**CITY OF SNELLVILLE
PLANNING & DEVELOPMENT DEPARTMENT
BOARD OF APPEALS**

VARIANCE CASE SUMMARY

CASE NUMBER: #BOA 22-03

PROJECT: Signage Rebranding for the Hospital South Campus

PRIMARY DIRECTIONAL

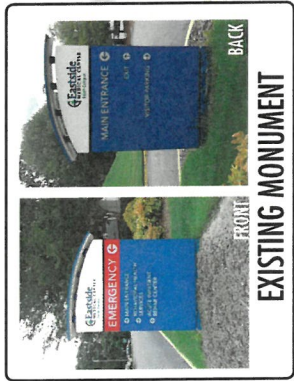
- PERMITTING INFO:
- CODE VIOLATIONS:
- 207-6.4.B.14.b (Max sign area 16 sf)
 - 207-6.4.B.14.d (One per intersection)
 - 207-6.6.A (10ft setback from curb)

SECONDARY DIRECTIONAL

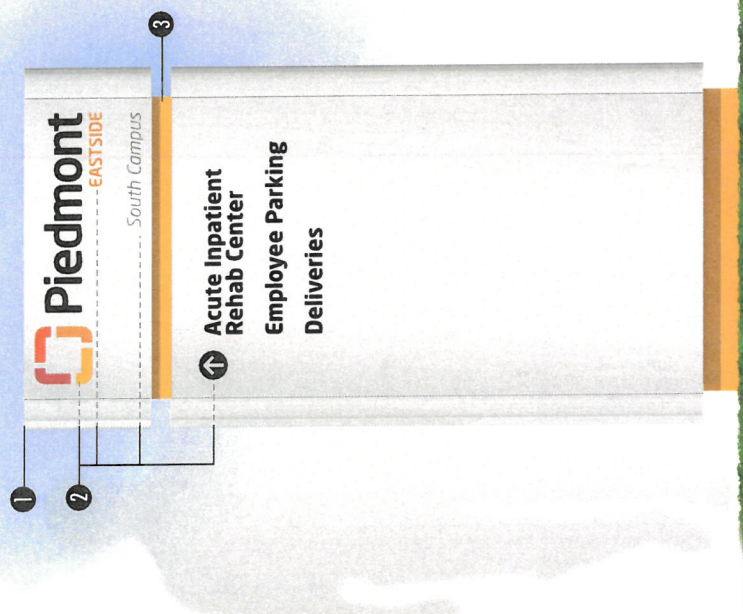
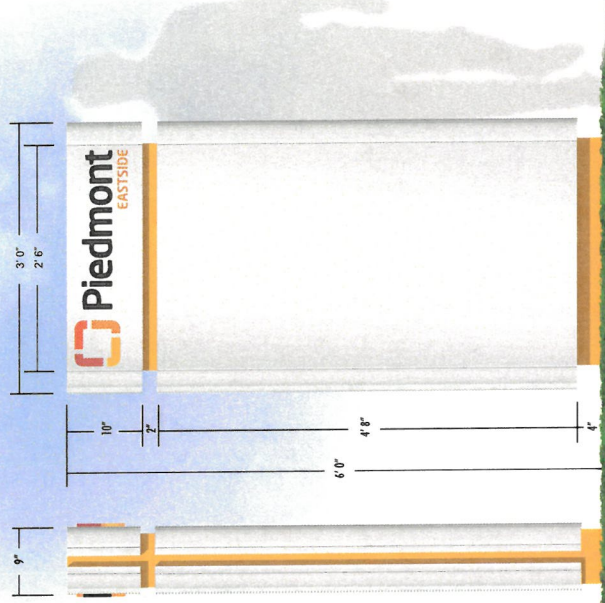
5	Secondary Directional	207-6.6.A 207-6.4.B.14.b 207-6.4.B.14.d	b. Maximum sign area of each sign may not exceed 16 square feet. d. Only one such sign may be located at each internal intersection of private driveway or public streets within the project. A. Setbacks Signs may not be located in the right-of-way and must be at least 10 feet from the back of the curb or edge of the pavement of the adjacent street, whichever is greater. Signs on a corner lot within 50 feet of the intersection of rights-of-way must be out of right-of-way or at least 15 feet from the back of the curb or edge of pavement of the adjacent streets, whichever is greater.	Proposed signage is closer to curbs inside the property lines than current code requirements. Proposed face sf = 15 sf Proposed overall sf = 18 sf Number of signs at intersection unclear. Proposed signage may not comply.
		207-6.6.A		Proposed signage is closer to curbs inside the property lines than current code requirements.

The Department of Planning and Development recommends **Approval** of the variances from the Sign Ordinance for signs numbered 3, 4 and 5 identified on the Signage Variance Matrix attached as Exhibit "A" and shown on the sign details attached as Exhibit "B".
